Model: S-C5	Date: 21-Mar-12	No.: RD127001b
-------------	-----------------	----------------

Subject: Firmware Release Note: (Java VM v10 for eDC)		Prepared by: H. Tamaki	
From: 1st Tech Service Sect., MFP/Printer Tech Service Dept.			
Classification:	<input type="checkbox"/> Troubleshooting	<input type="checkbox"/> Part information	<input type="checkbox"/> Action required
	<input type="checkbox"/> Mechanical	<input type="checkbox"/> Electrical	<input type="checkbox"/> Service manual revision
	<input type="checkbox"/> Paper path	<input type="checkbox"/> Transmit/receive	<input type="checkbox"/> Retrofit information
	<input type="checkbox"/> Product Safety	<input checked="" type="checkbox"/> Other (Firmware)	<input checked="" type="checkbox"/> Tier 2

This RTB has been issued to announce the firmware release information for the **Java VM v10 for eDC**.

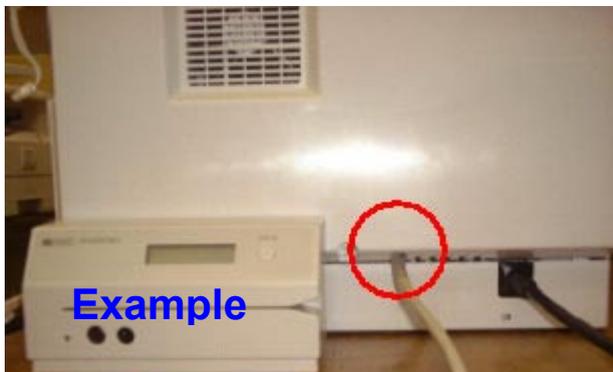
Important: Route the vendor's harness through the cut-out hole shown in Step 2.

SYMPTOM

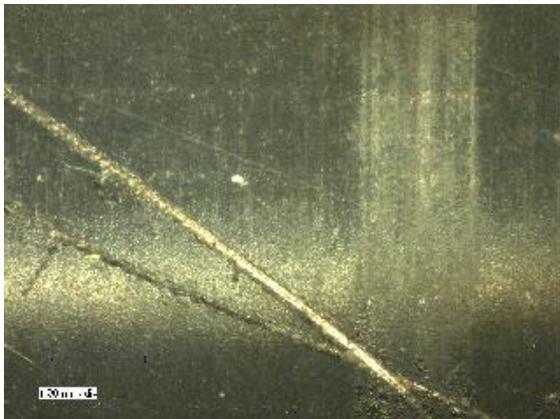
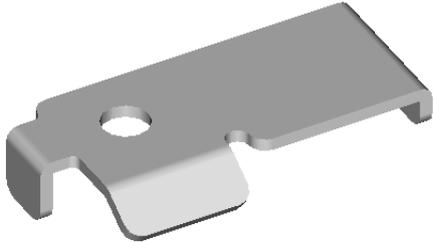
If you find some scratches on the fusing roller, it is possible that the customer tried to remove the jammed paper from the fusing unit by using a sharp object.

In this case, the thermistor may be damaged.

Next, if the thermistor and its harness are visible, add the thermistor cover (p/n: D1274180) by the following procedure.

D1274180: Thermistor Cover

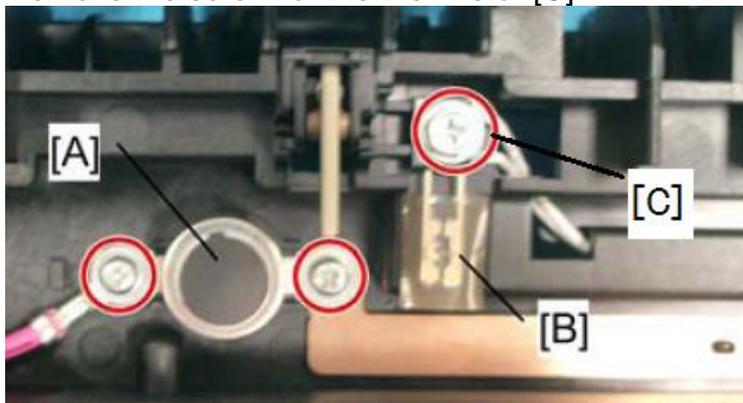
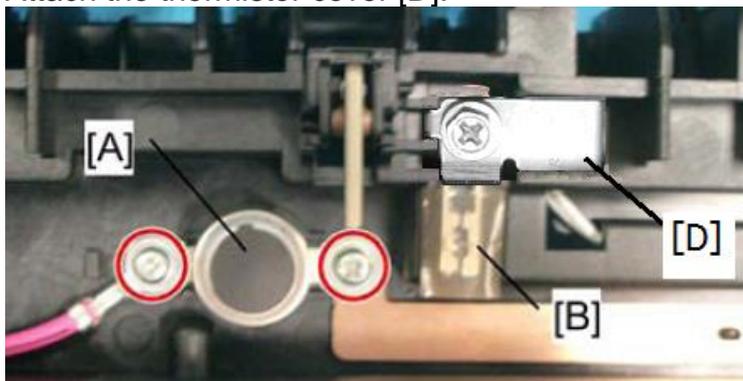
11. Remove the screw for the thermistor [C].

12. Attach the thermistor cover [D].

CAUSE

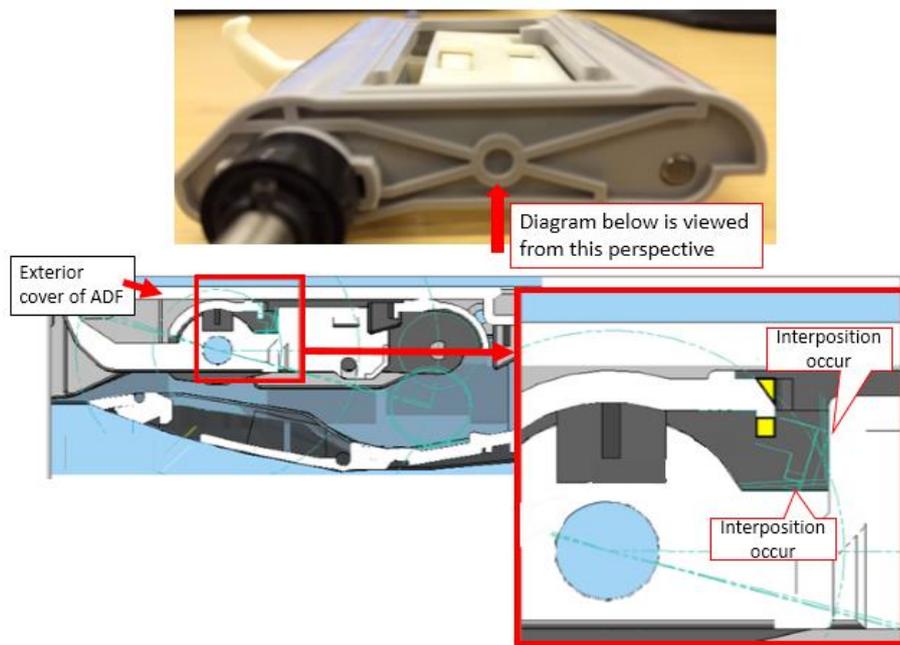
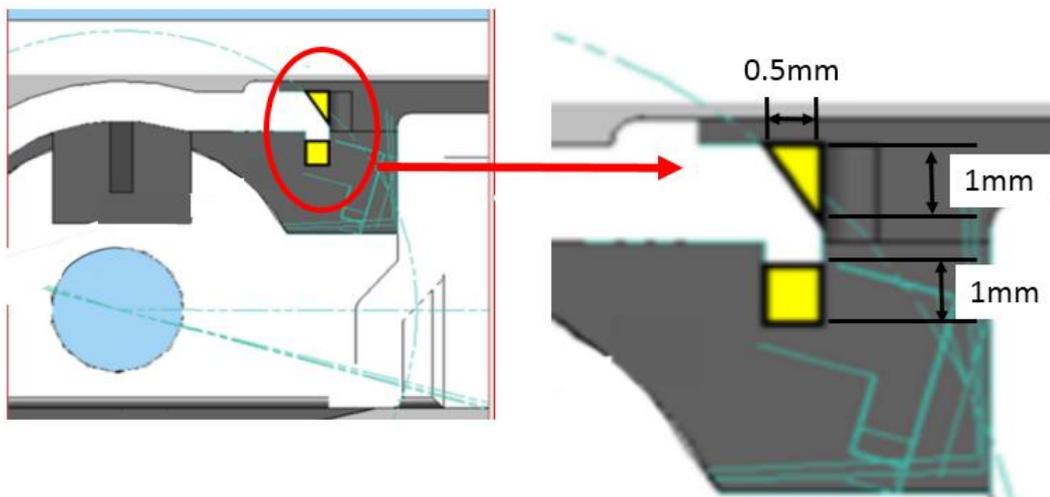
1. The customer uses an unsupported thin paper type (approx. 0.33gsm or thinner), which causes the ADF feed unit to interfere with the movement of the pick-up roller. As a result, the pick-up roller cannot be lowered to the proper position.

SOLUTION

<Before>

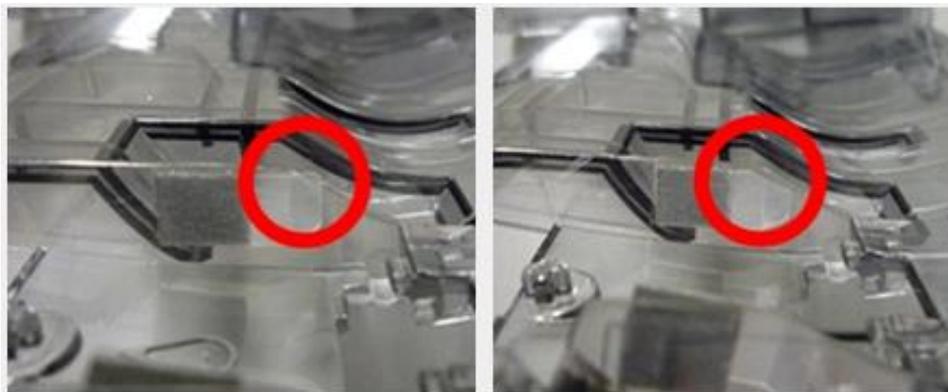
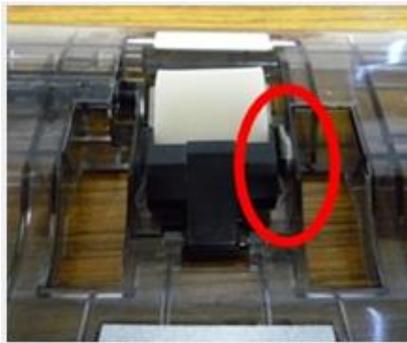
4. Replace the separation cushion (with P/N D6063119) **OR**, cut off the portion of the Mylar that is sticking out.

<After>

Replacement Procedure (bypass paper end sensor bracket)

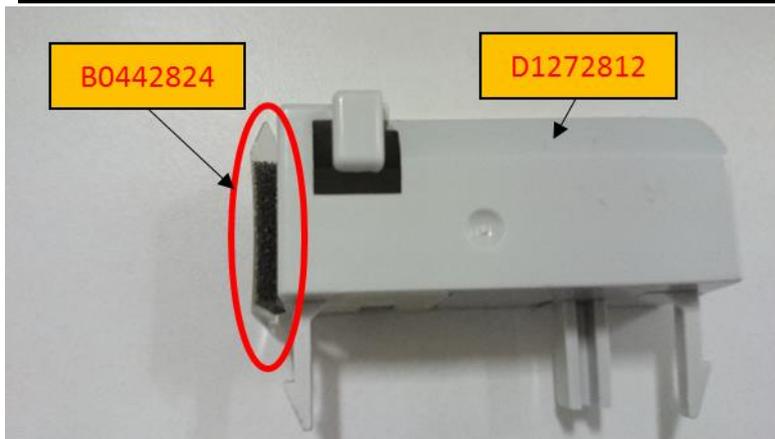
Change: The bracket for the bypass paper end sensor was registered as a service part.

1. Clean the attachment area for the sponge (B0442824) with alcohol.
2. Attach the sponge to the bracket (D1272812), as shown below.

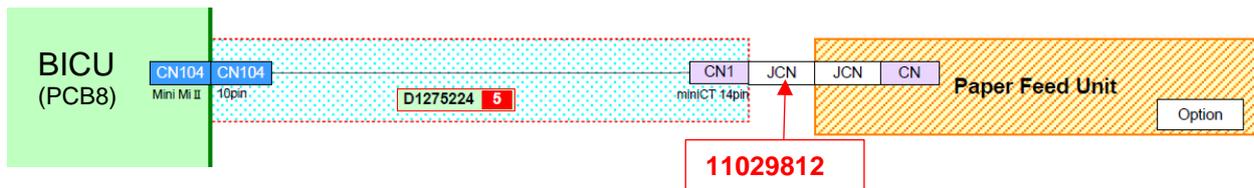
Change: The parts is newly added.

Part number	Description	Q'ty	Int	Page
11029812	CONNECTOR:1-1612257-4	1	-	1/9
